MANDATORY SERVICE BULLETIN NO.
MSB 40-103 / MSB F4-042 / MSB D4-114 / MSB 40NG-084
REV. 2

Type: DA 40 / DA 40 D / DA 40 F / DA 40 NG

Actions to prevent Passenger Door Separation: Installation of Placards, AFM Procedure update and Inspection/Data Gathering.

WORK INSTRUCTION
WI-MSB 40-103 / WI-MSB F4-042 / WI-MSB D4-114 / WI-MSB 40NG-084
REV. 2

Figure 2.

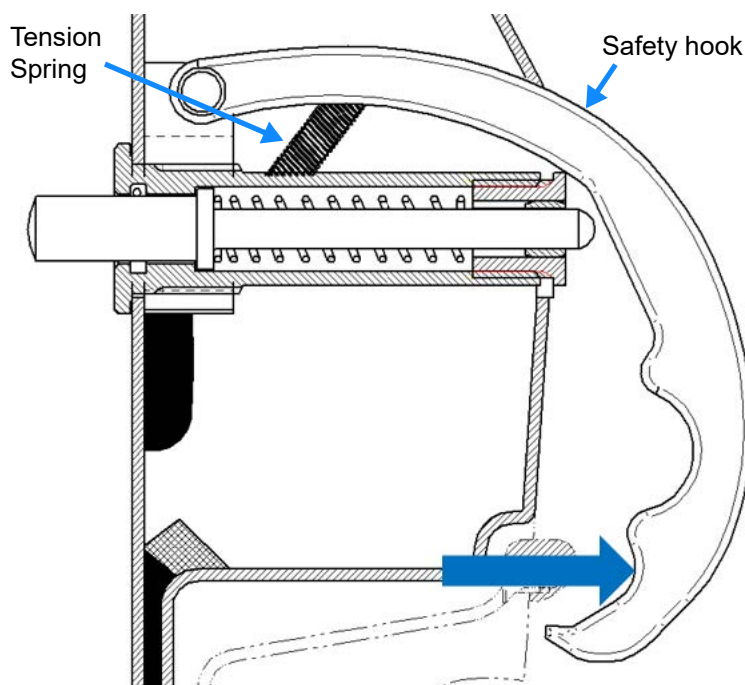
6. Check the condition of the tension spring and the force to lift the safety hook from its resting position as follows:
Refer to Figure 2.
- Open the passenger door.

- Examine the tension spring of the safety hook. Use a borescope through cutout in the door, if corrosion, deformation or damage is found, take note and replace it after this WI is completed. Refer to Section IV for removal and installation of the hook assembly.

- Lift the safety hook and release it.
 - After releasing the force, the safety hook must snap back into its resting position.
 - If the safety hook does not snap back into its resting position, do the following:

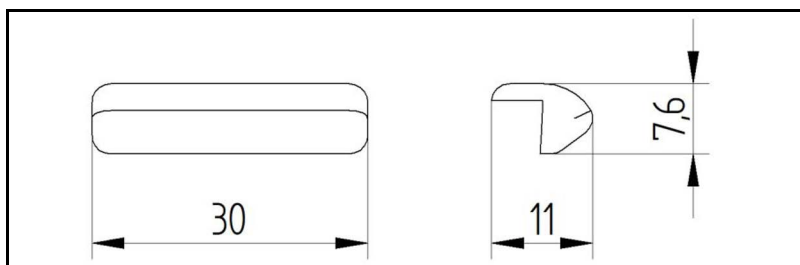
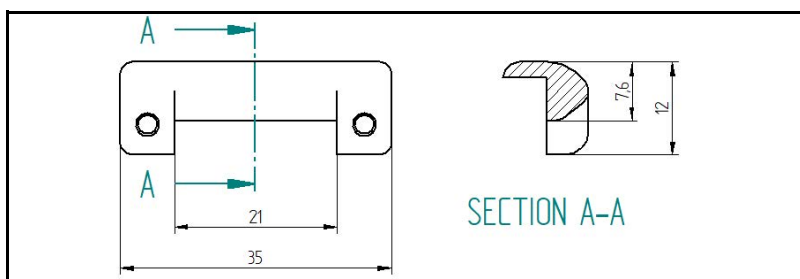
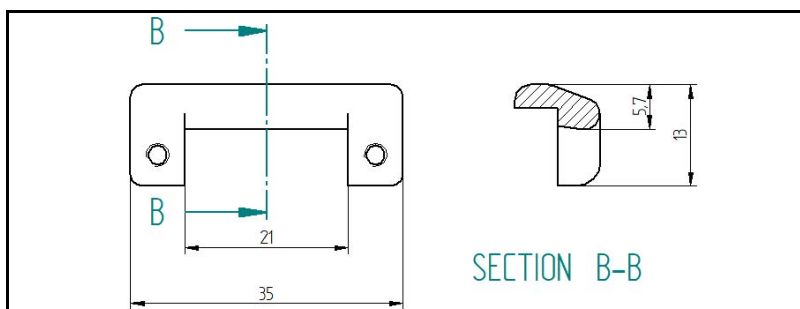
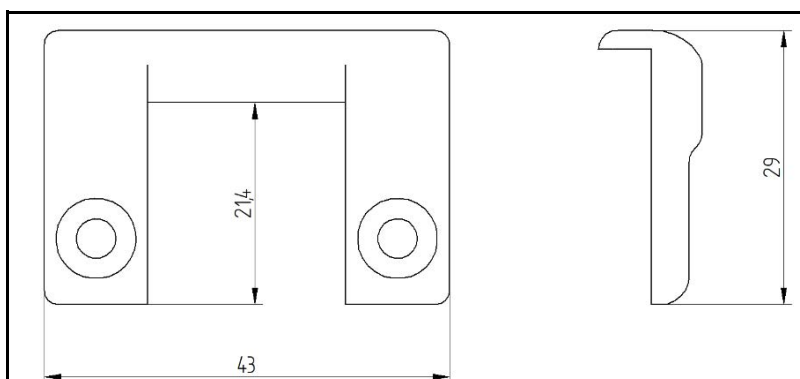
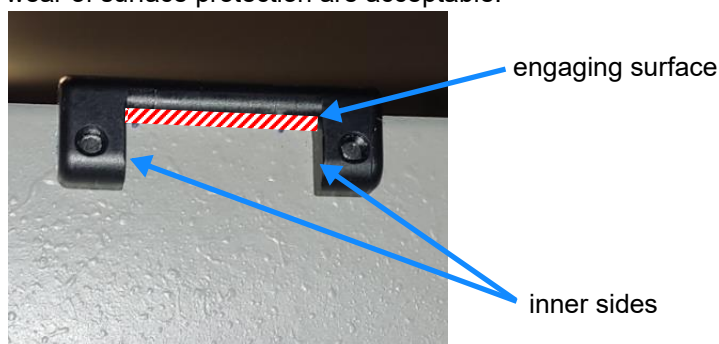
7. Identify the version of the retaining block:
Record the version in the execution report.

Small (DA4-5200-00-69)

Extended without undercut (DA4-5200-00-69_1)

Extended with undercut (DA4-5200-00-69_02)

Long extended (DA4-5200-00-69-SB)

Figure 4.

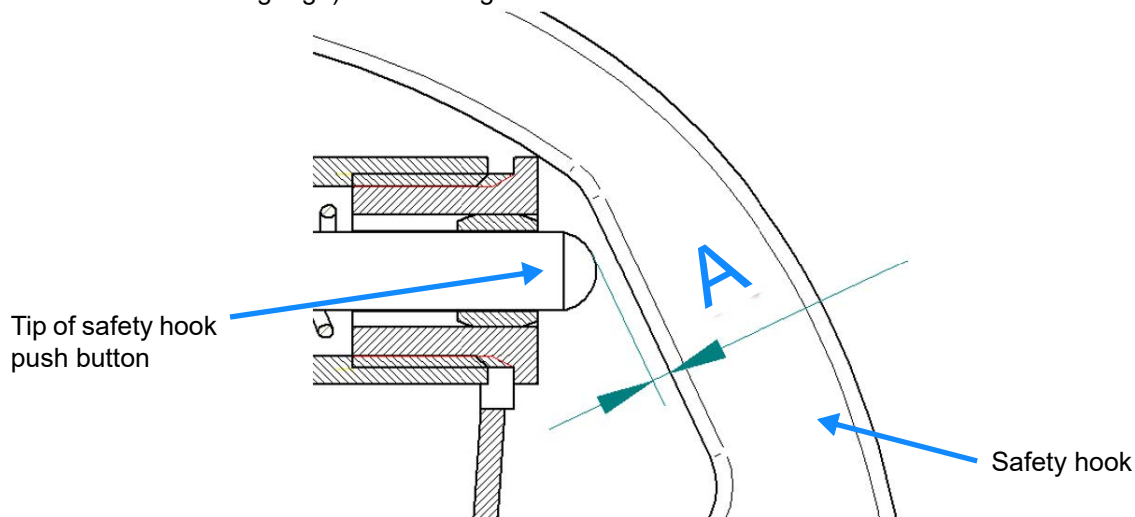
- Dimension A: distance of push button to the safety hook in resting position (e.g. with a feeler gauge). Refer to Figure 4.

Figure 5.

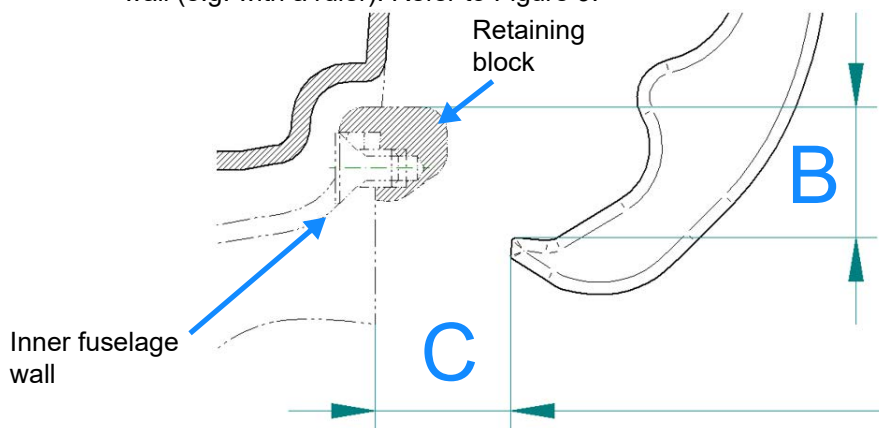
- Dimension B: distance between the top surface of the retaining block to the top surface of the engaging section of the safety hook in resting position (e.g. with a ruler). Refer to Figure 5.
- Dimension C: horizontal distance between the tip of the safety hook and the fuselage wall (e.g. with a ruler). Refer to Figure 9.

Figure 6.

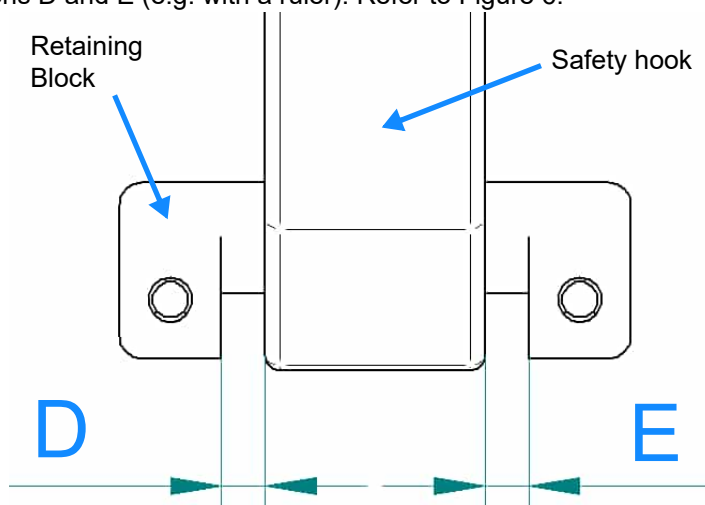
- Dimensions D and E (e.g. with a ruler). Refer to Figure 6.

Figure 10.

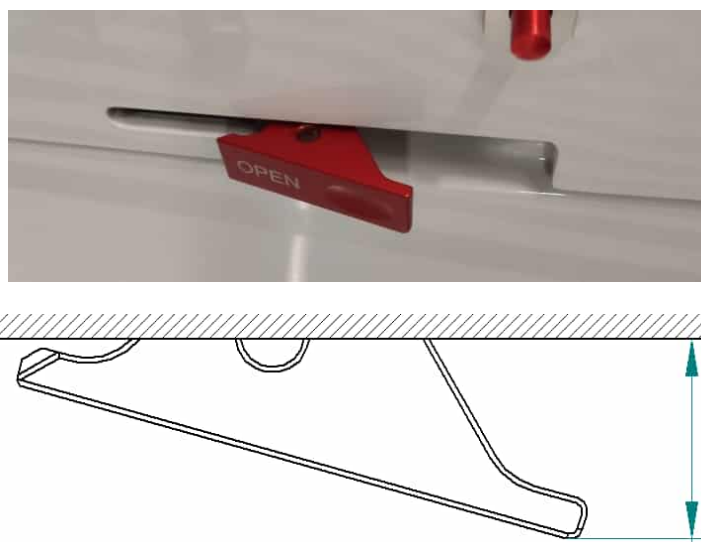
15. If the old passenger door latch is installed (refer to step 14), visually inspect the spring:
Refer to Figure 10.
- a) Move the passenger door handle to the unlatched position.
 - b) Visually inspect the spring.
 - Look specifically for a broken winding, replace the spring if found broken.
 - c) Record any findings on the execution report in Appendix A.

Figure 11. Protrusion measurement

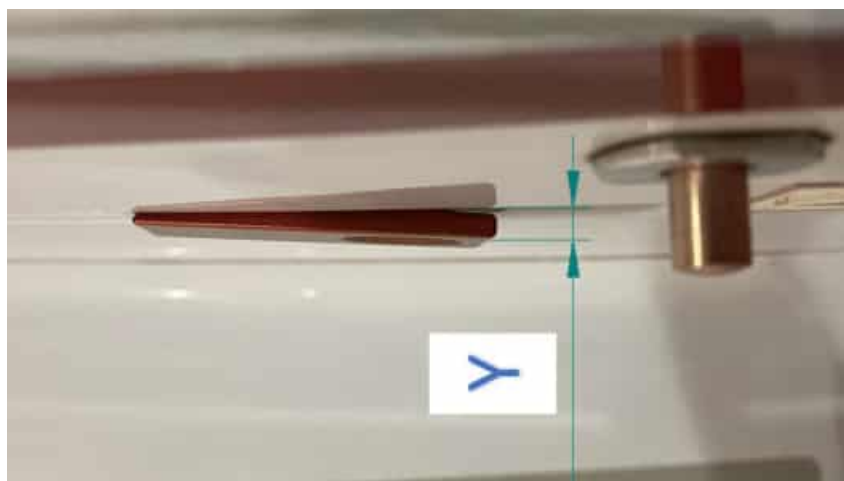
19. Data collection: Position of the external passenger door handle. Refer to Figures 11 and 12.

- a) Close the passenger door.
- b) Push the external passenger door handle into the latched position until it stops.
- c) Examine if the passenger door handle is recessed, flush or protruding over the passenger door surface.
- d) Record the condition of the passenger door handle on the execution report in Appendix A.
- e) If the handle protrudes from the surface of the passenger door, measure the protrusion.
- f) Record the measurement on the execution report in Appendix A.

Figure 18. Example of **NOT** acceptable condition of door guide block

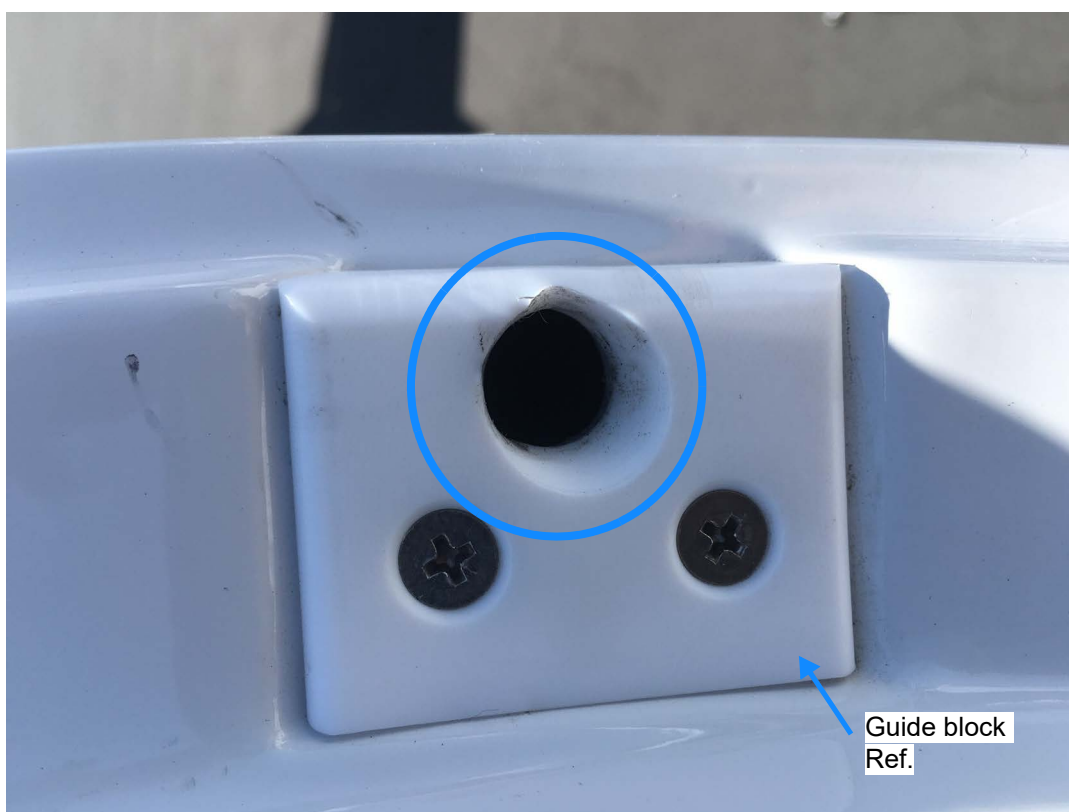
23. Inspect the front and rear door guide block for damage. Refer to Figure 18.

- a) Open the passenger door.
- b) Visually check the condition of the guide block.
 - The guide block must not have worn edges, dents, cracks.
 - If you found any damage, take note and replace the guide block after the WI is completed. Refer to section IV for the replacement.
 - Record any damage of the guide blocks on the execution report in Appendix A.

Figure 29.

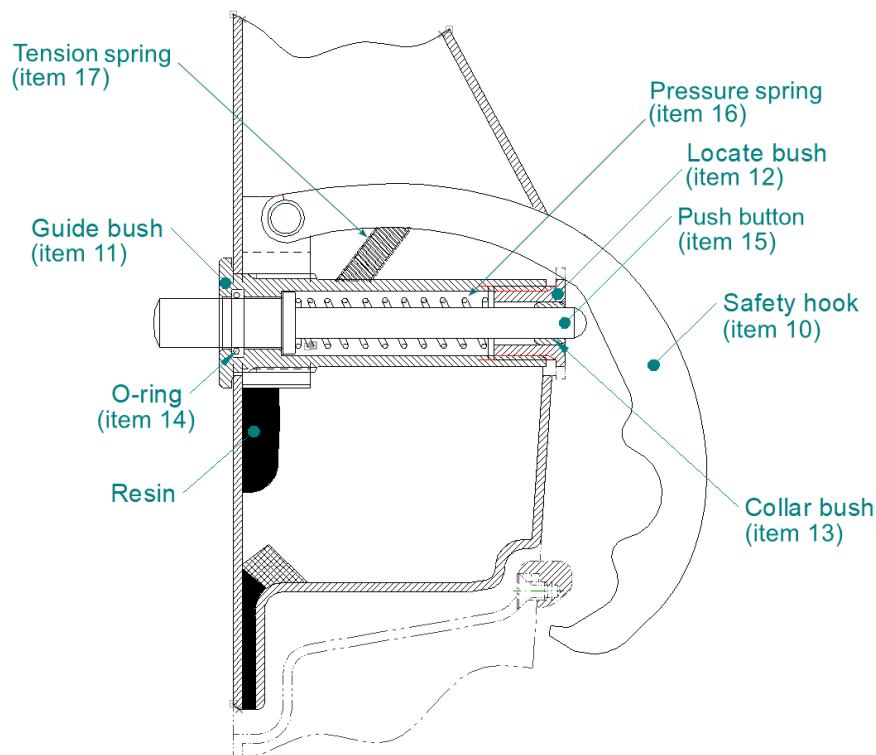
Refer to Figure 29.

1. Remove the inner door handle to get access to the inside of the door. Refer to AMM Section 52-10.
2. Unscrew the guide bush and locate bush to release the push button assembly.

3. Remove the hook assembly from aircraft through the handle opening and place it on a work table to replace safety hook.
4. Remove screw that secures the tension spring on the safety hook.
5. Remove cotter pin to release safety hook, pin and washers.
6. Install the new safety hook (item 10) using the pin, washers and cotter pin.
7. Reinstall tension spring using the screw to secure it. Use Loctite 262 (item 6) to screw, refer to manufacturer instructions for proper use.

8. Replace any defective parts of the push button.
9. Reinstall hook assembly to the aircraft door:
 - a) Route the hook assembly through the handle opening and secure to outside door shell with guide bush (item 11).
 - b) Insert collar bush (item 13) into locate bush (item 12).
 - c) Apply a small amount of Vaseline (item 8) to o-ring (item 14) and insert into guide bush.
 - d) Insert push button (item 15) and pressure spring (item 16) into guide bush (item 11) and screw guide bush and locate bush (item 12) together.
 - e) Apply ITW Plexus MA300 (item 9) or thickened resin (5 min epoxy + cotton flakes) to the bearing block on the inside of the door. Refer to Figure 30 and the manufacturer instructions for proper use.
10. Record the replacement on the execution report in Appendix A.

Figure 31.

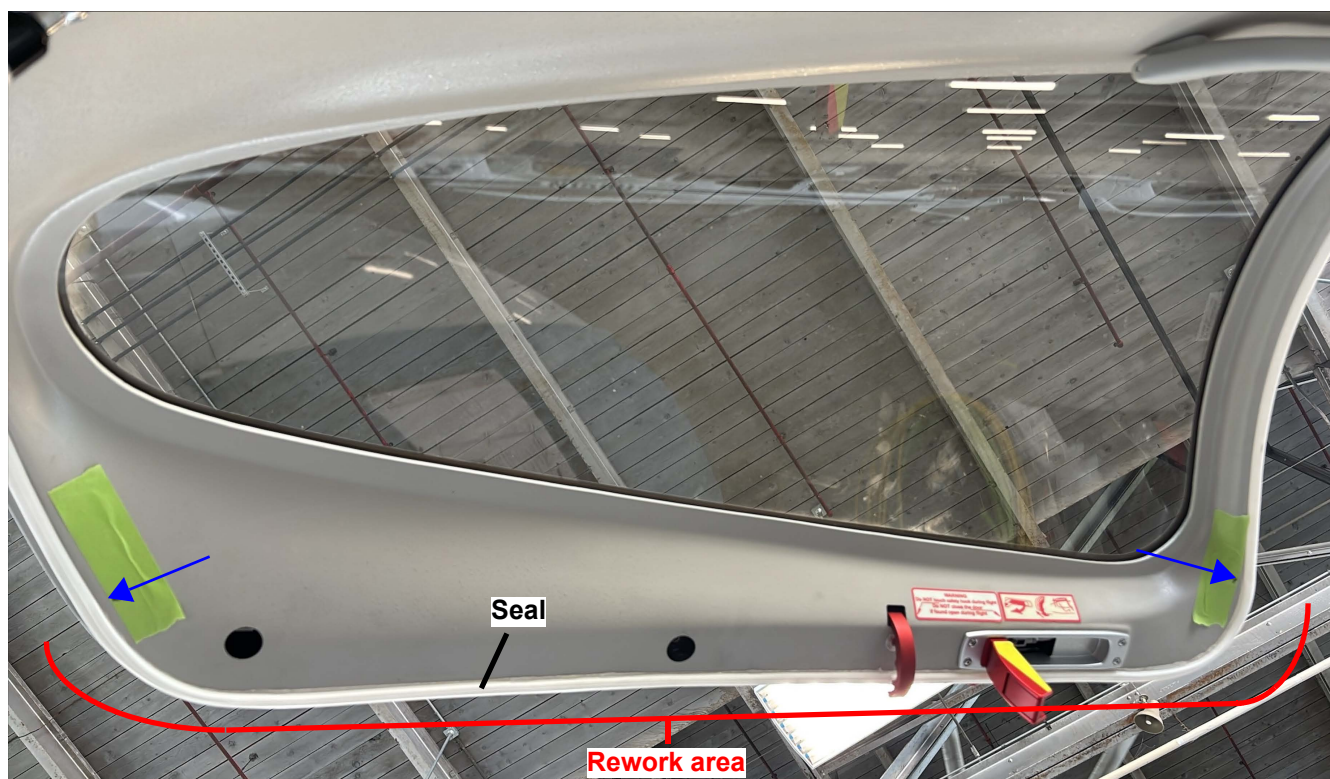
1. Carefully remove the door seal from the door only in the rework area specified in Figure 31. Be careful not to damage the seal during removal. Leave the seal hanging.
2. If required, remove existing sealant from the area where you removed the seal and clean the surface for the new sealant.
3. Apply 0-5 mm bead of clear silicone sealant (item 23) to the door.
4. Reinstall seal and allow sealant to cure. Refer to sealant manufacturers instructions.
5. Repeat step 20.c). and check if the force is between 2 kg (20 N) and 6 kg (60 N).
 - If the force is below 2 kg (20 N): Reapply sealant up to maximum allowed and repeat test. If test cannot be passed, replace gas spring.
 - If force is above 6 kg (60 N): Remove sealant, apply a thinner layer of sealant and repeat test.
